Roundabout Traffic & Safety Assessment and Functional Design Review

Airport Road Environmental Assessment, King Street to
Huntsmill Drive

Prepared for Region of Peel
by IBI Group
August 9, 2019

A *Roundabout Functional Design Review – 1st Review draft* was completed on September 18, 2018 by John Bayley, P.Eng and Mr. Sergei Filippov, C.E.T. The design review provided observations, suggestions and comments on the functional aspects of each of the three roundabouts with inputs later incorporated into the designs, dated October 12 (refer to Exhibit 3-3, Exhibit 4-3, and Exhibit 5-3). Following the first review, *Roundabout Functional Design*

FIGURE 2A

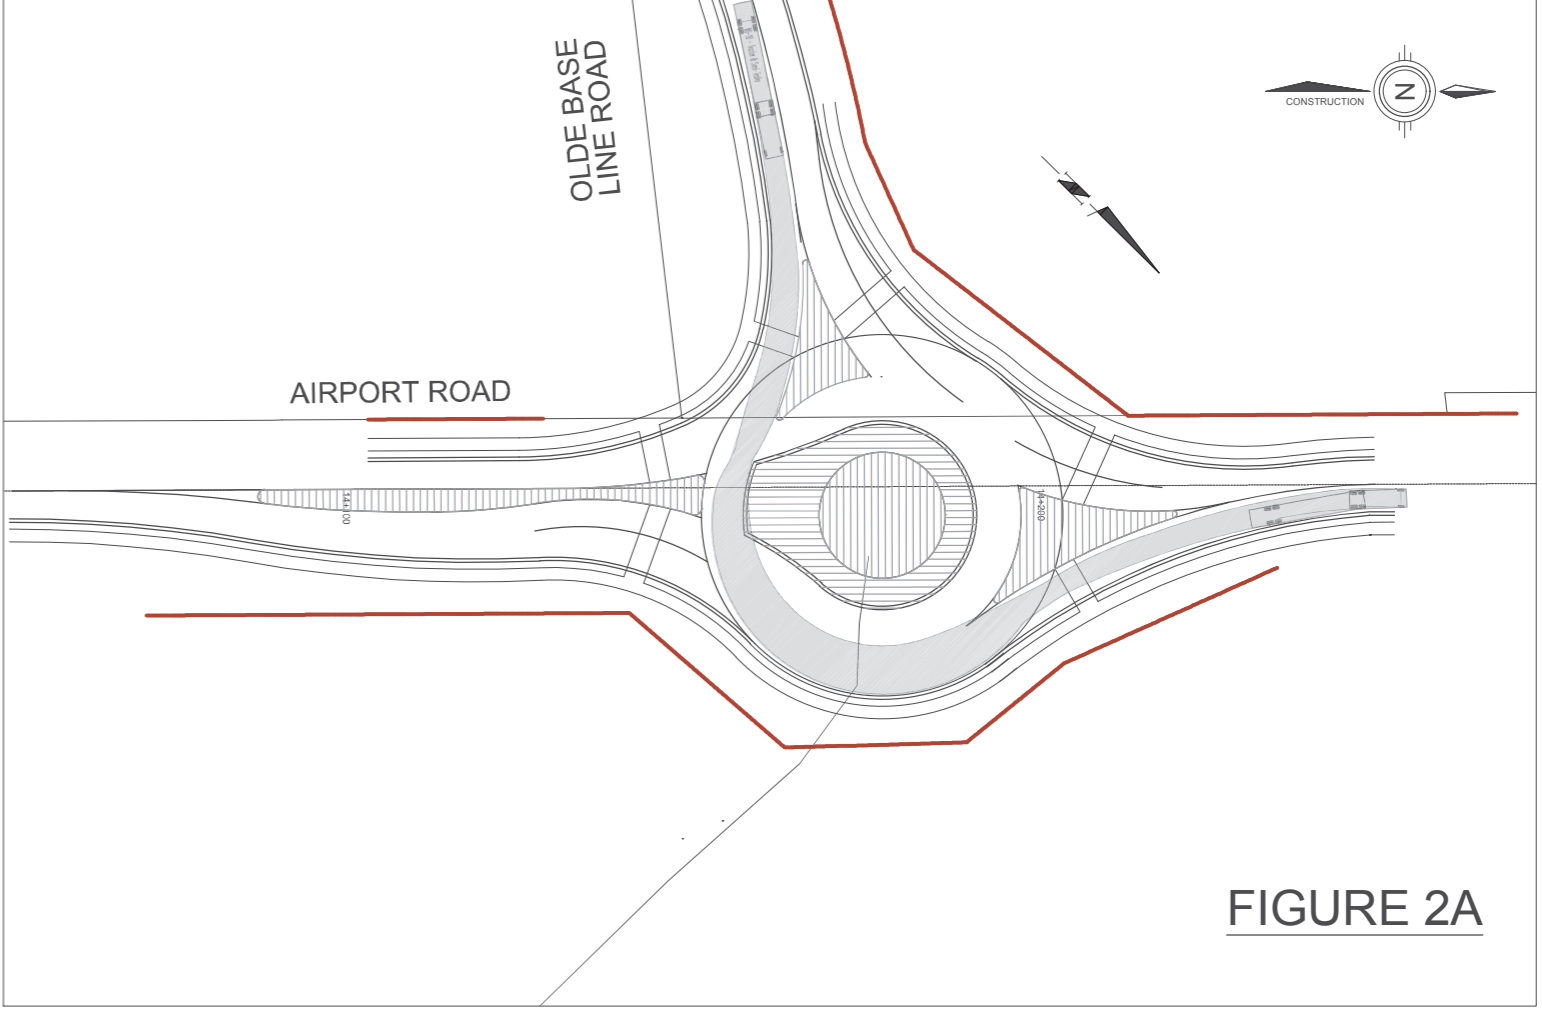
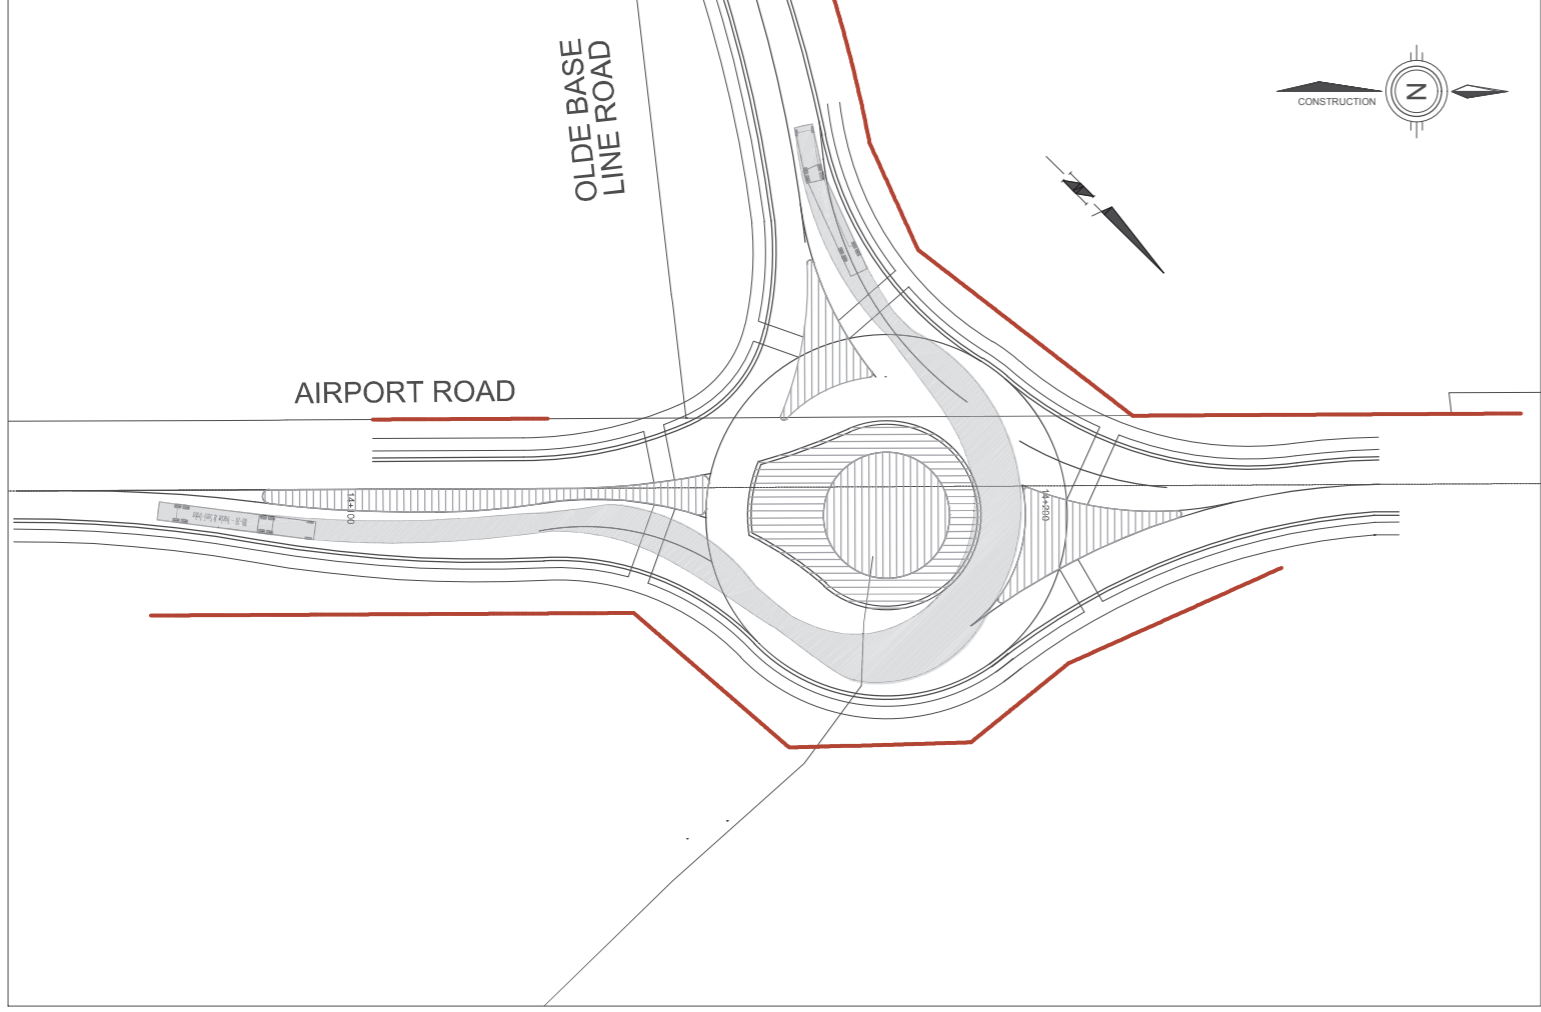
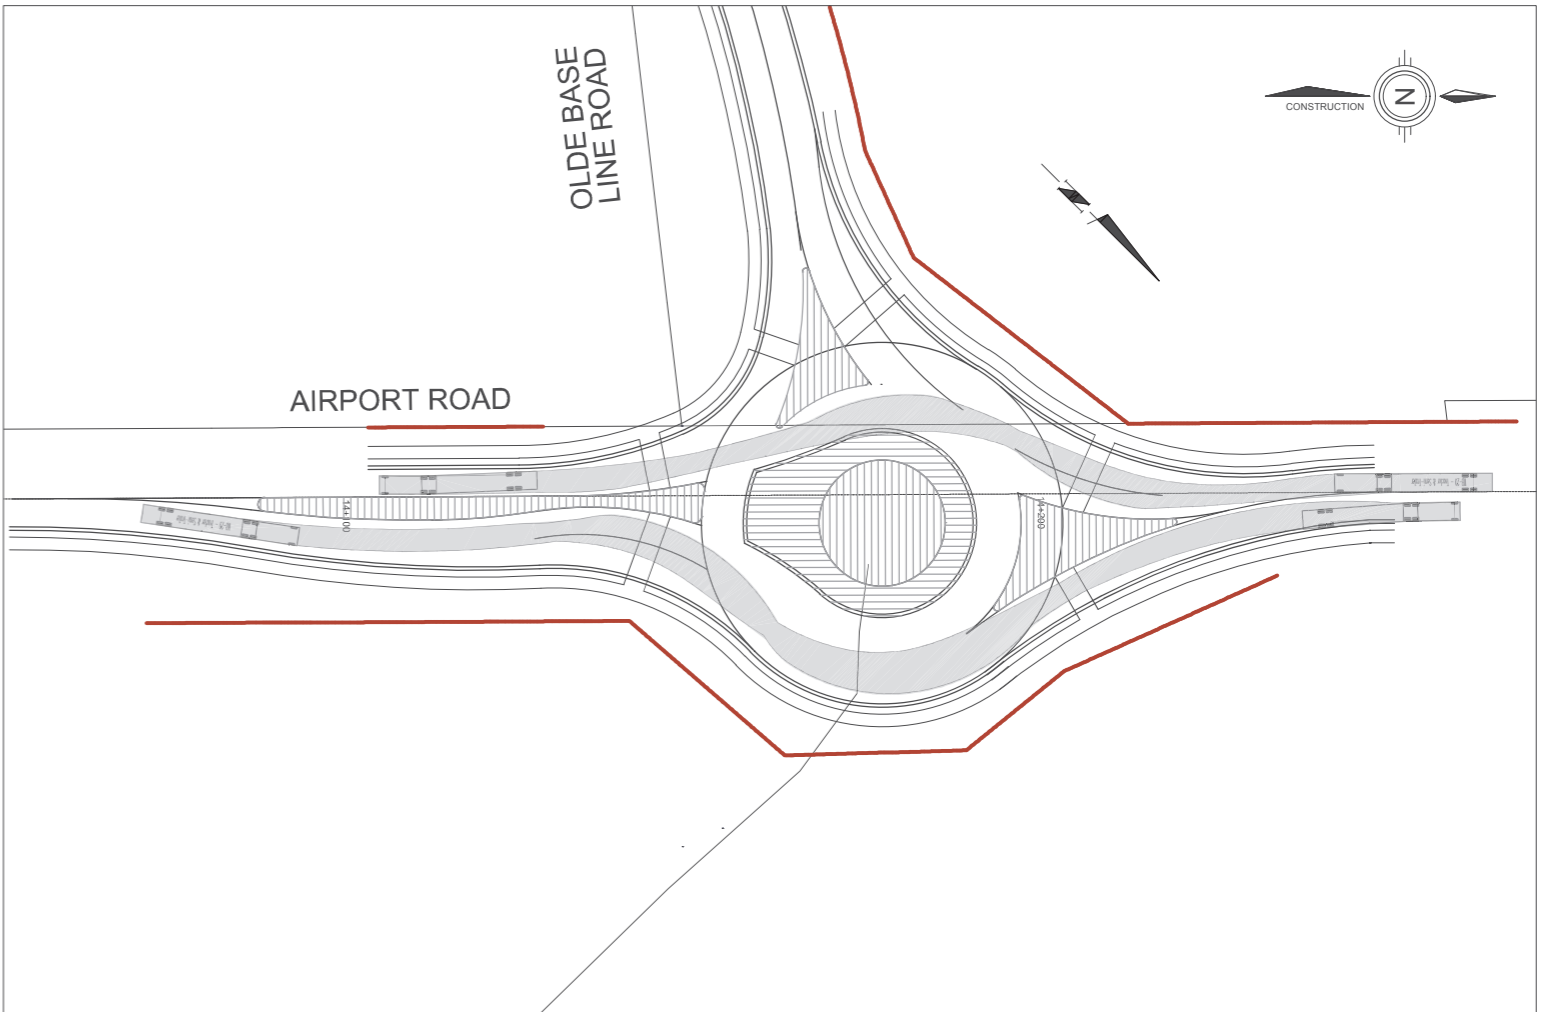
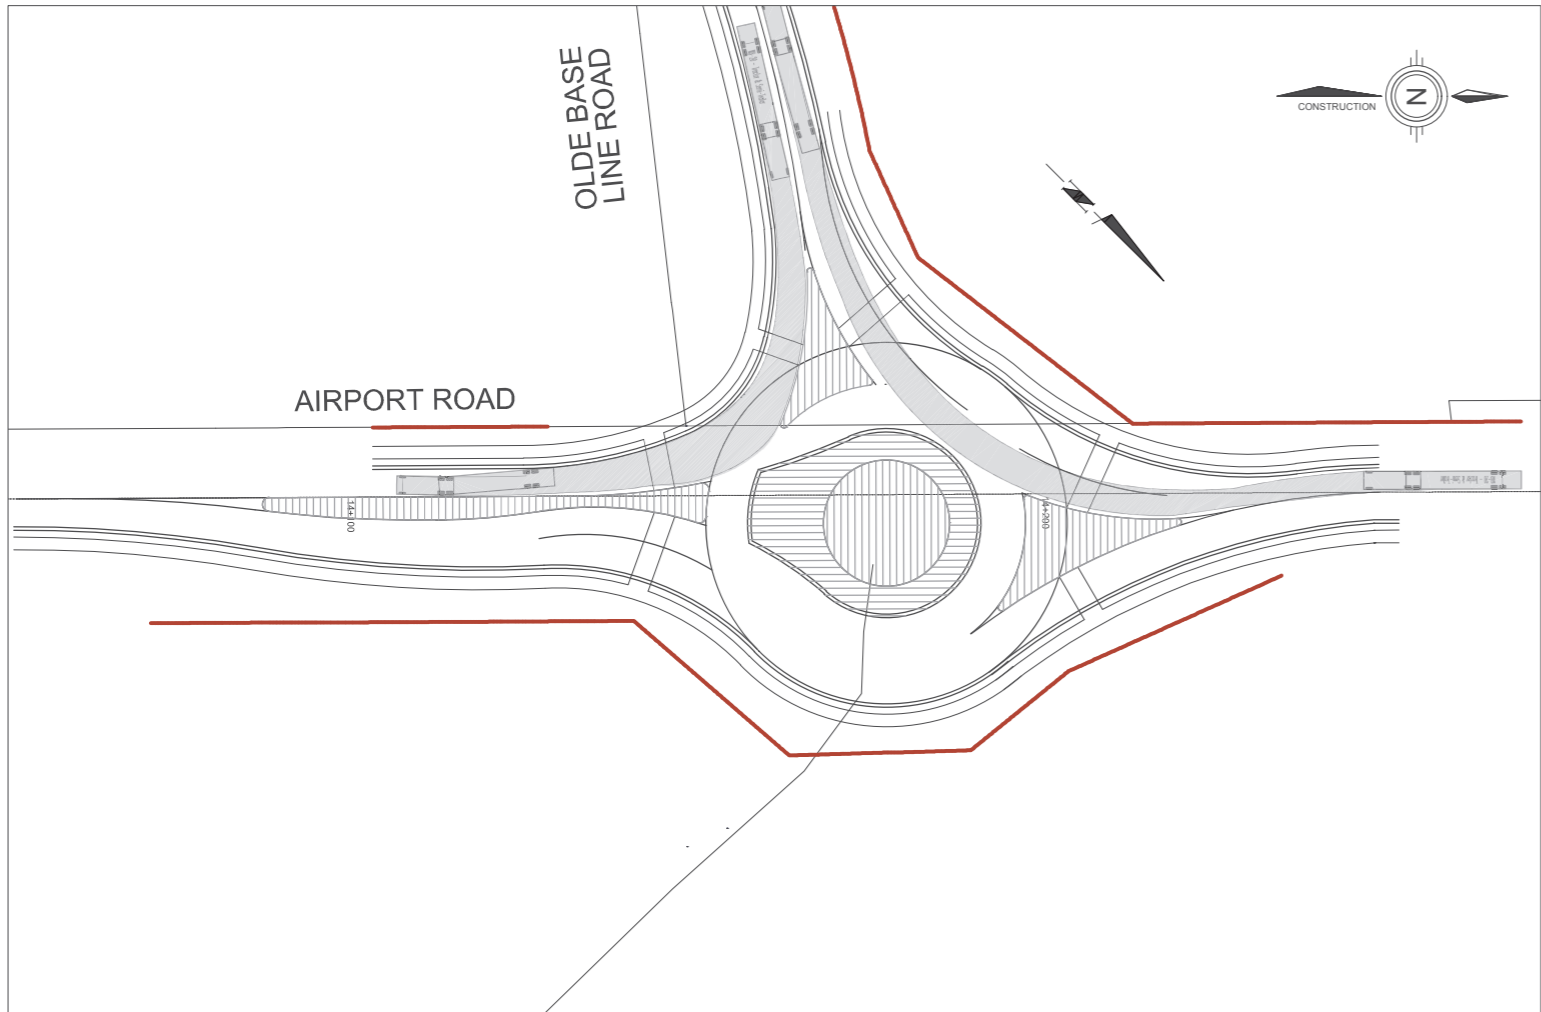
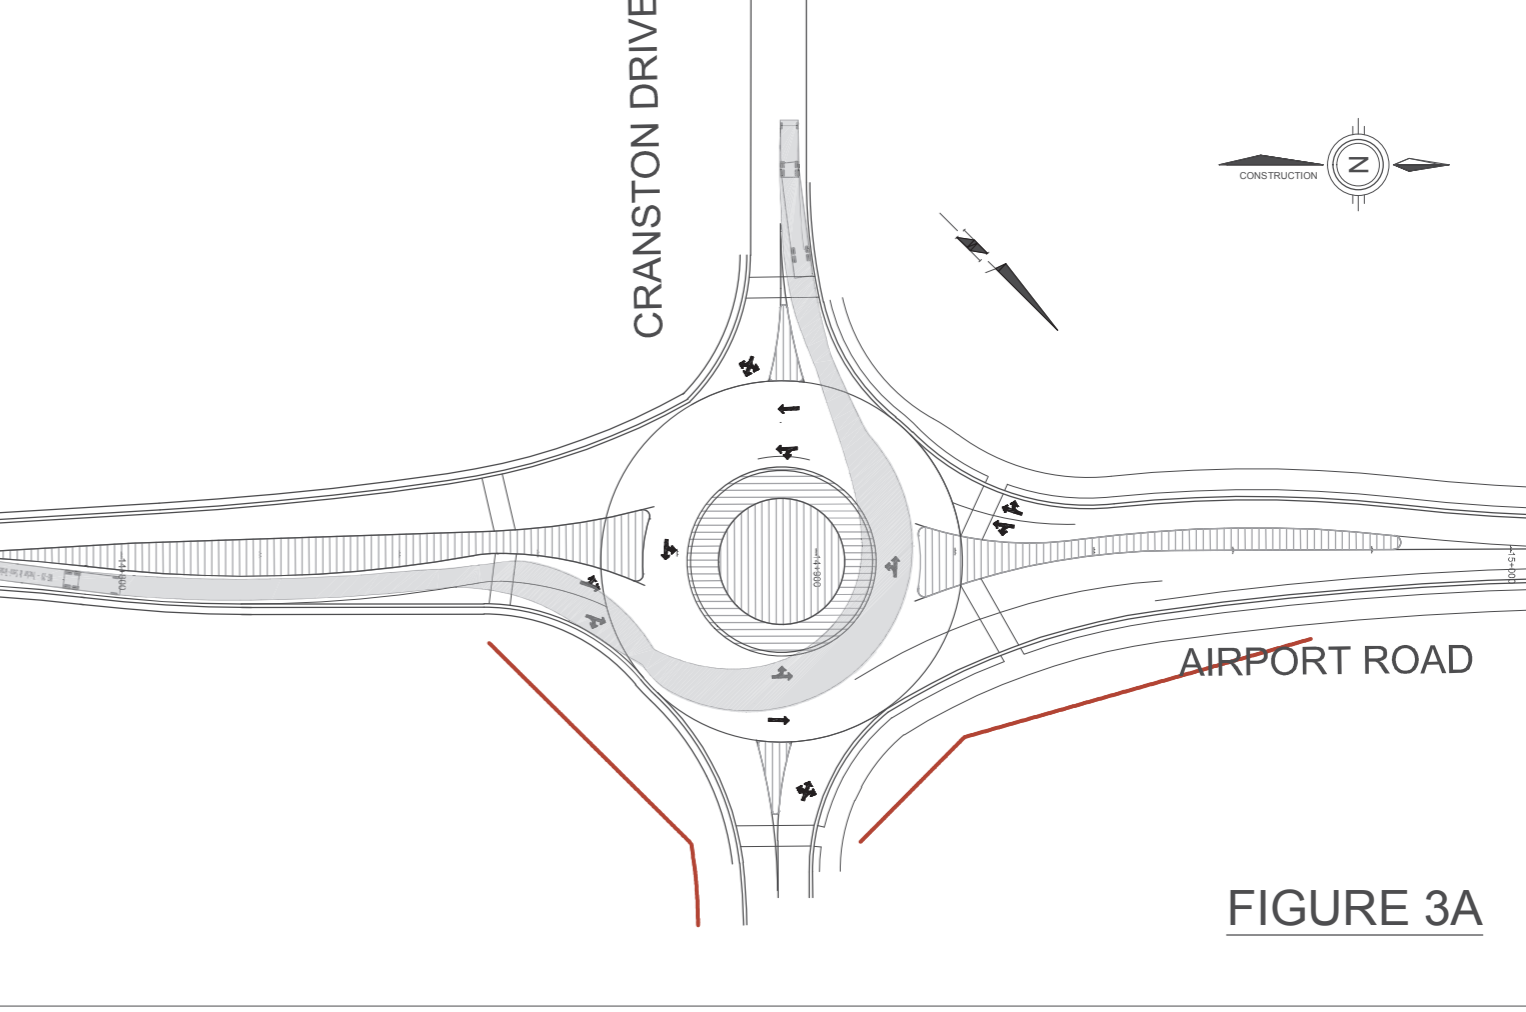
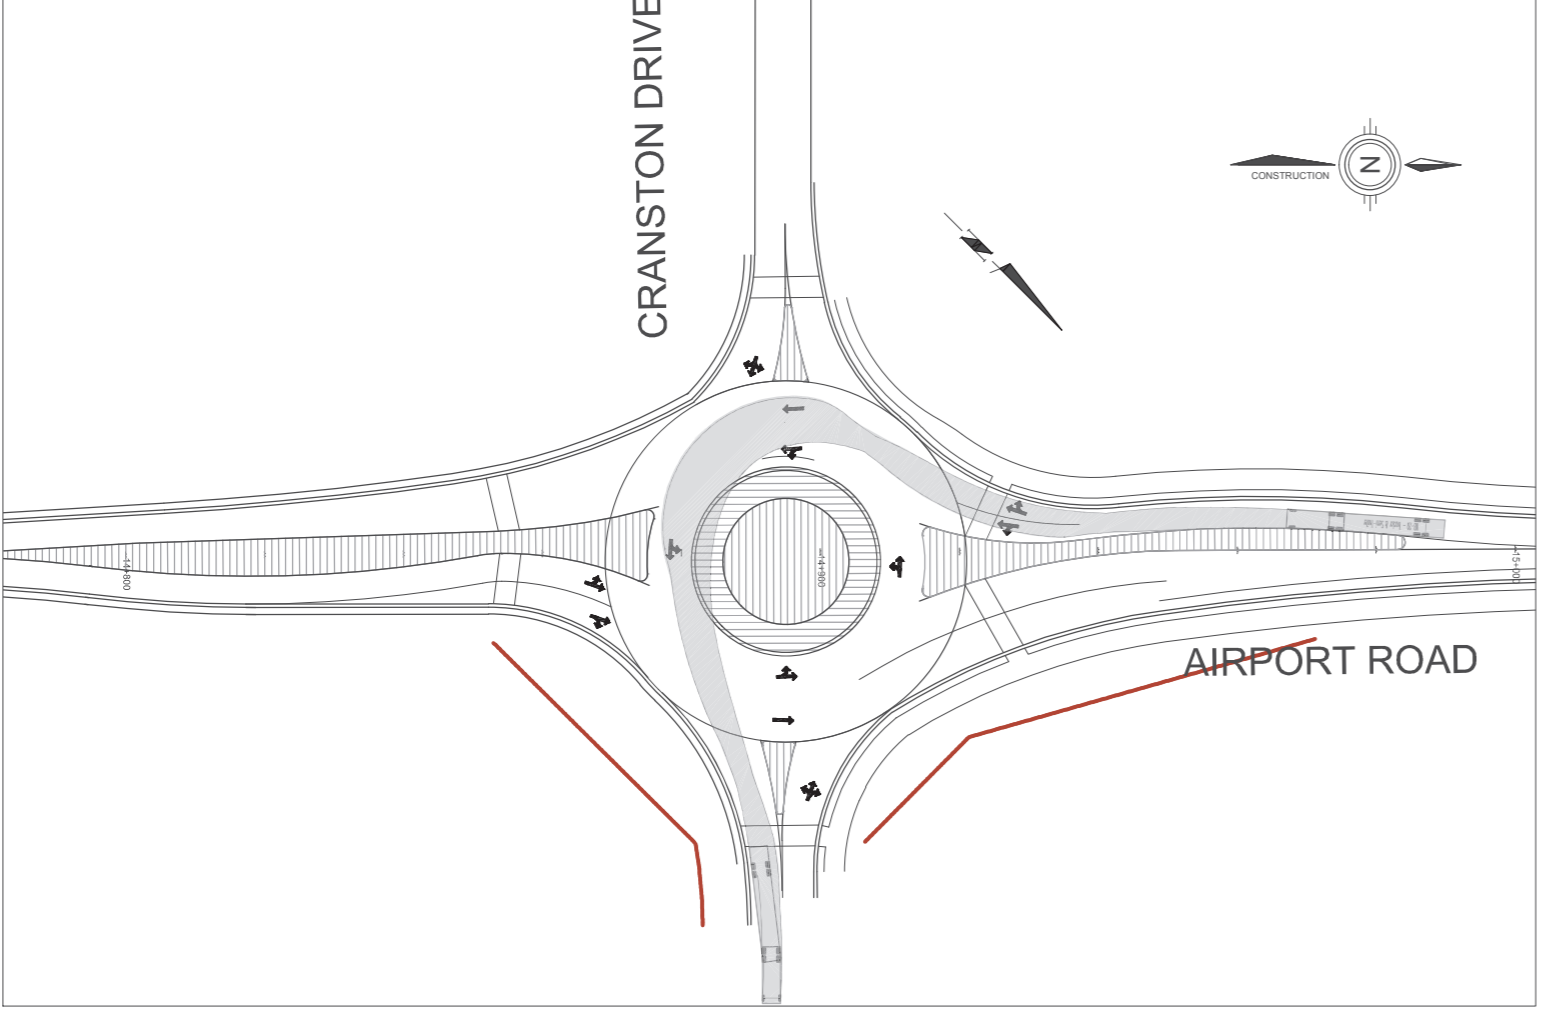
Swept Path Analysis: Preliminary review – WB-20 design vehicle – see attached Figure 2A.

Truck Turning – See Swept Path analyses in Figure 2A. The revised design appears to be acceptable to accommodate all WB-20 truck movements.
